RDM # 3 - Dewpoint South – Dolsontown Road Town of Wawayanda, Orange County, New York Colliers Engineering & Design Project No. 20006912E

The following items are in response to comments contained in the Creighton Manning Engineering; LLP (CM) letter dated August 1, 2023. Also enclosed here for your convenience and reference is a copy of our August 3rd letter (the "August 3rd Letter"), enclosed as **Attachment A**.

CME's specific comments are restated and addressed below:

- West Access SD-1A
- Caskey Lane Sheet 1 of 3

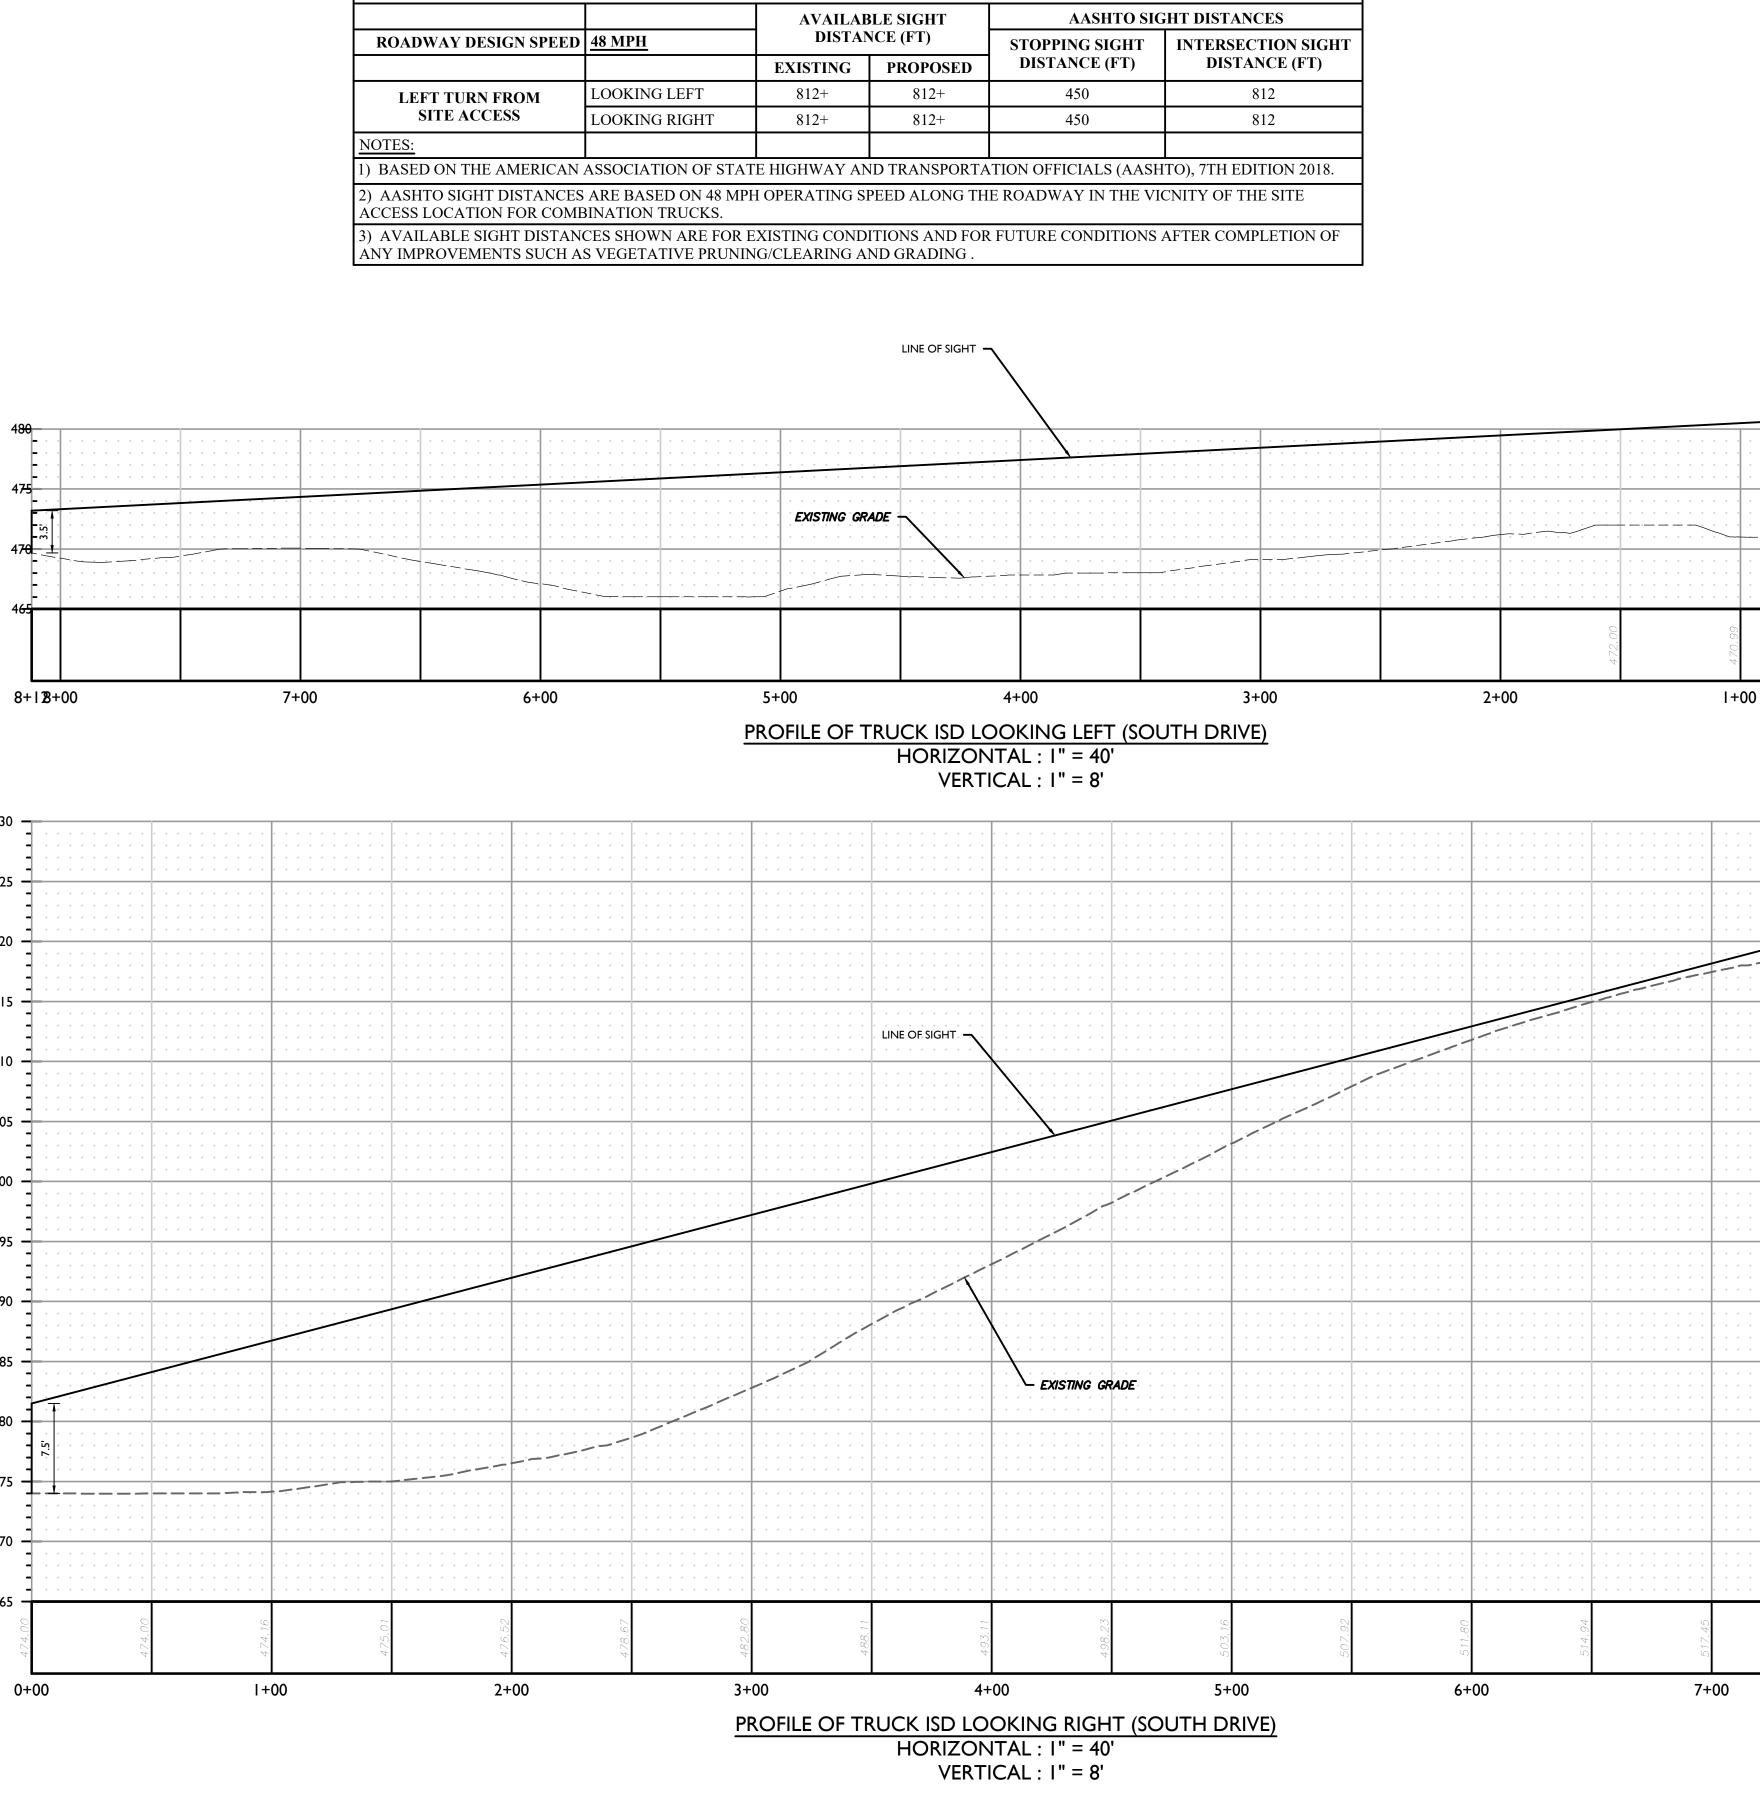
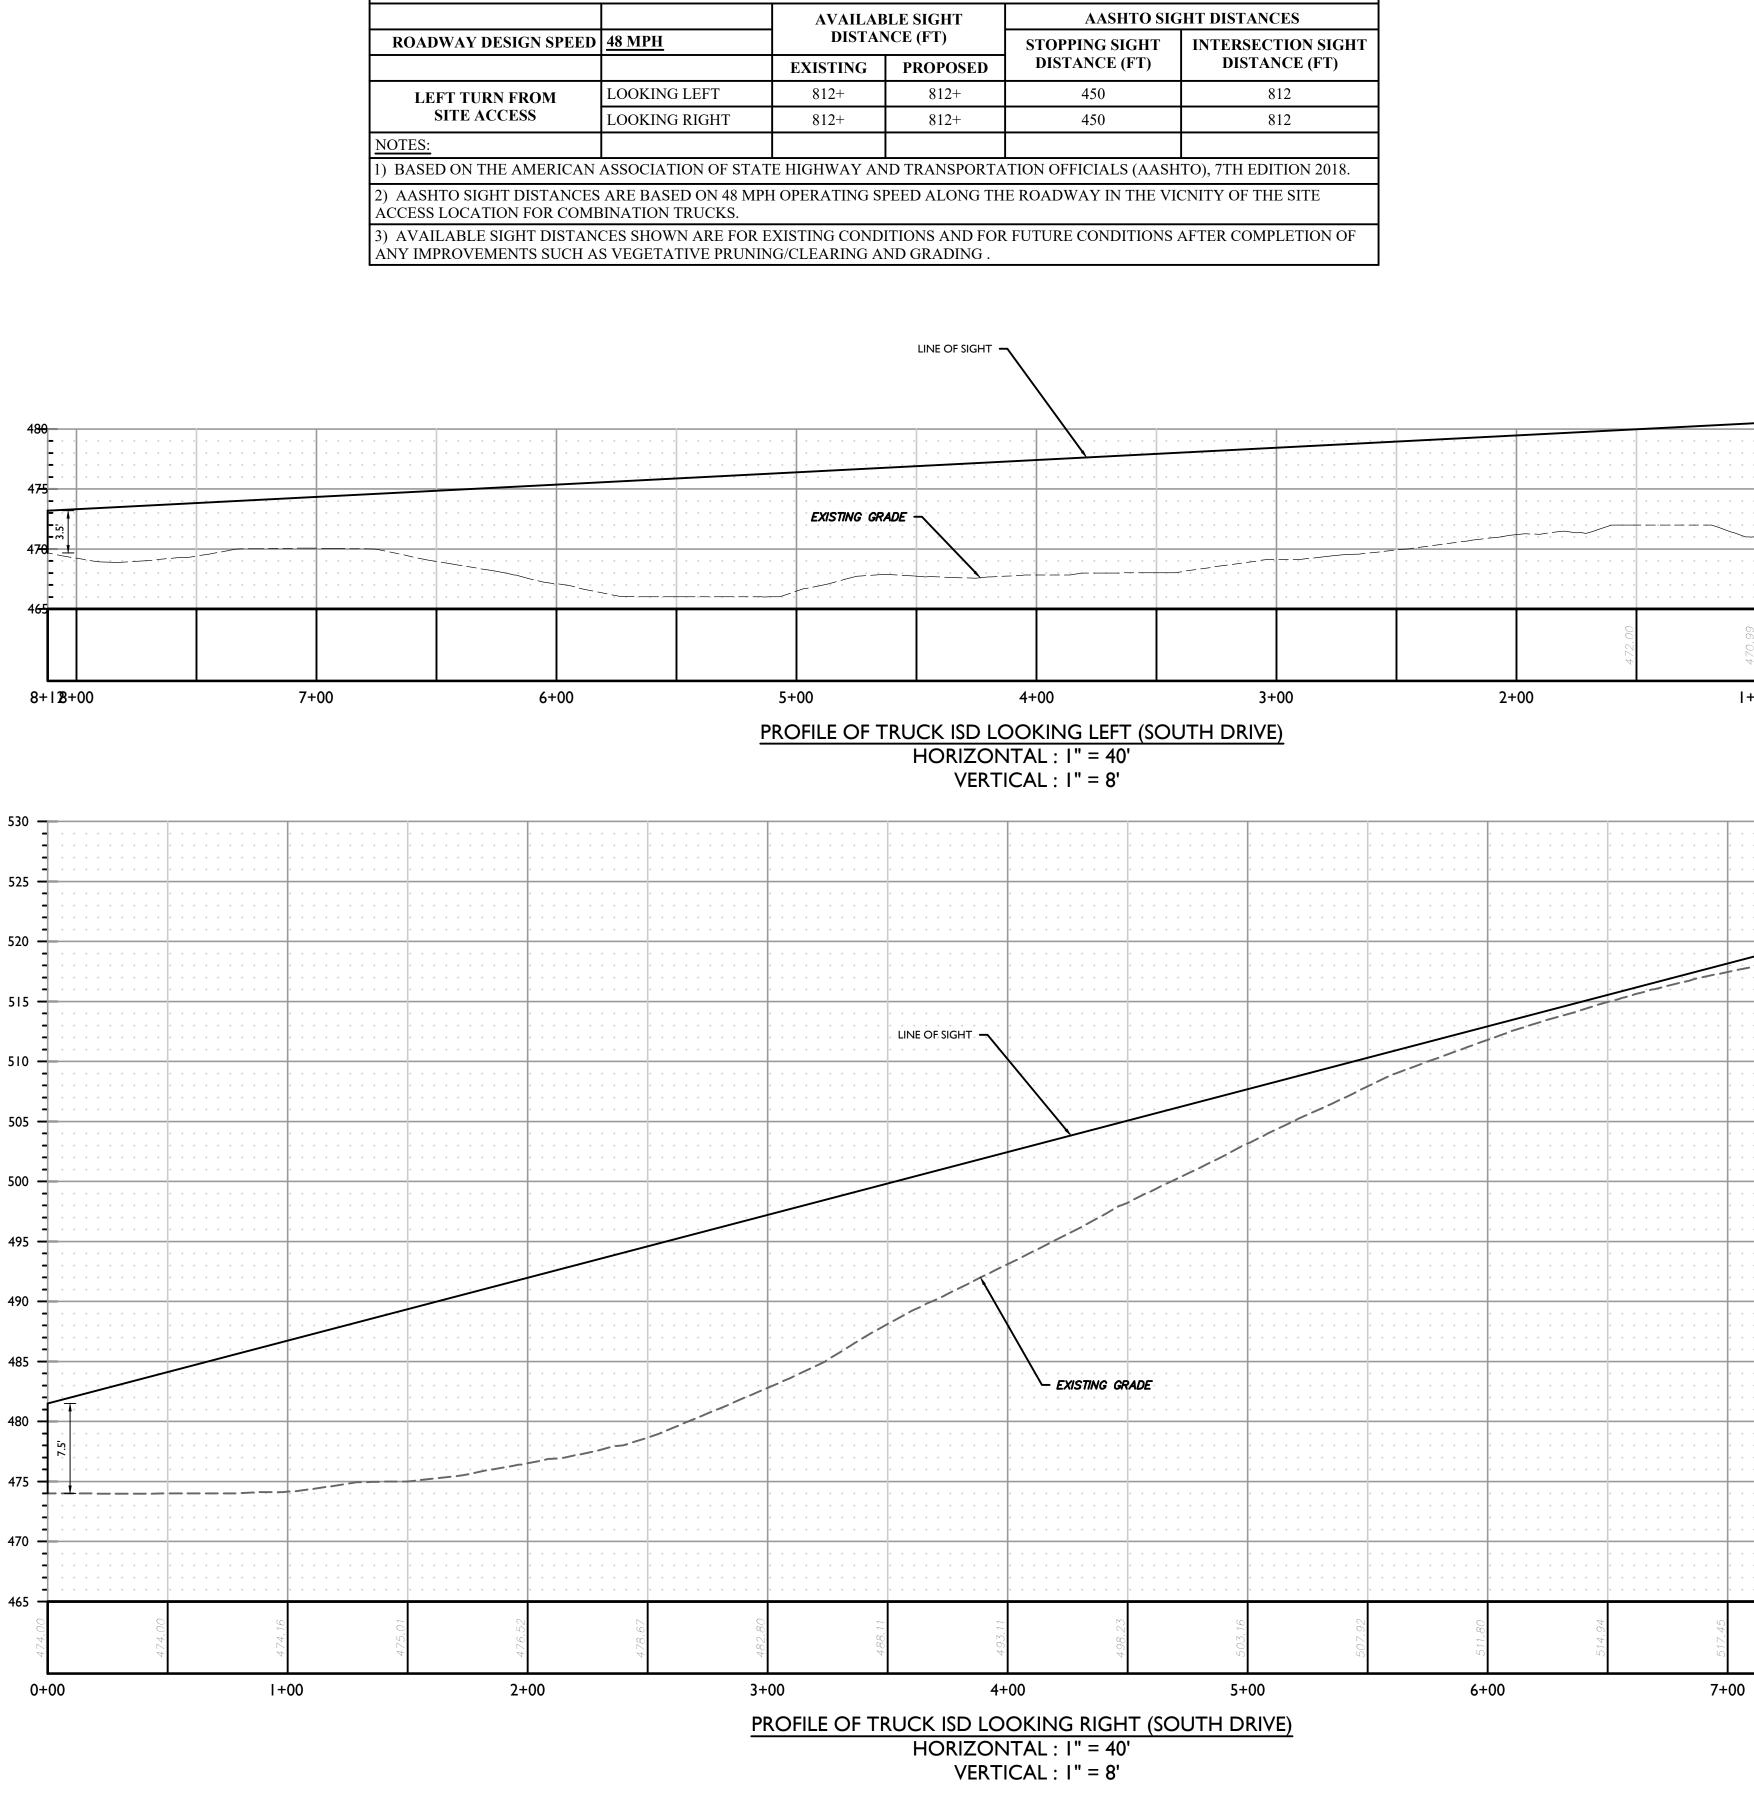
1. Establish sight distances to/from the west driveway.

Response: The sight distances were established for the west access as part of the GEIS Process. We are supplying them again with this submission on Sheet SD-1A. See Attachment C.
